**COMMONWEALTH OF KENTUCKY
BEFORE THE PUBLIC SERVICE COMMISSION**

ELECTRONIC 2024 INTEGRATED RESOURCE)	
PLAN OF DUKE ENERGY KENTUCKY, INC.)	Case No. 2024-00197
)	
)

SIERRA CLUB’S PUBLIC POST-HEARING COMMENTS

Figure 3: Commitment Status for East Bend 2

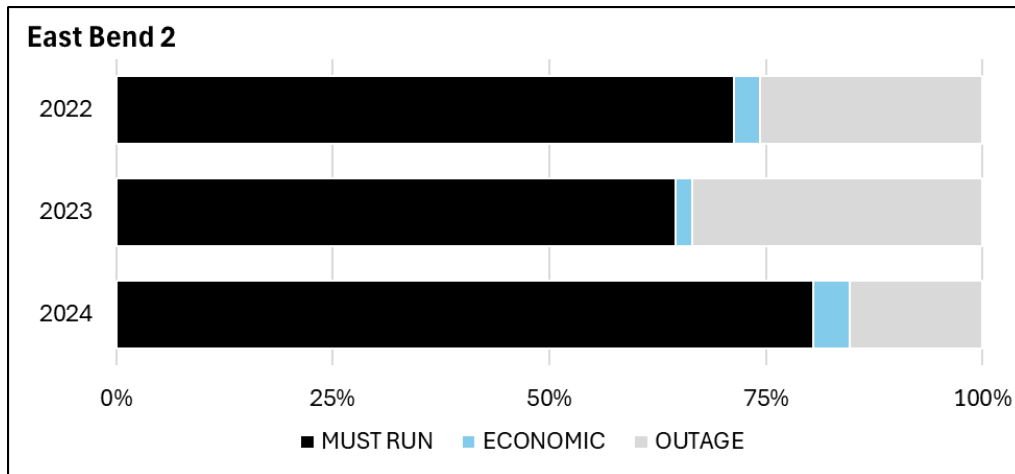
Moreover, compounding the overall negative economics, the East Bend unit would likely perform better on the energy market if it were allowed to commit on an “economic” basis by PJM. But instead Duke often forces the unit to operate by “self-commitment” or submittal as a “must-run” offer in PJM. Thus the Company tells PJM that the unit will be on-line at a certain minimum capacity (also called “economic minimum”) the next day and PJM can then decide to operate the unit further if it is cost-optimal (i.e., dispatch it at a higher output). Duke does this for almost every hour of the year—as shown below in Figure 3.

Duke is forcing the unit to operate even at hours where its variable costs fall below the market price offered by PJM, leading Duke to lose additional money for operating a costly unit. PJM offers “make-whole” payments which ensure that there are no net monetary losses on daily basis—*but only if the unit is economically committed*. Duke is unwisely foregoing these payments by committing the unit as must-run. Regardless of the commitment status, the Company should have considered early retirement and replacement given the unit’s poor performance.
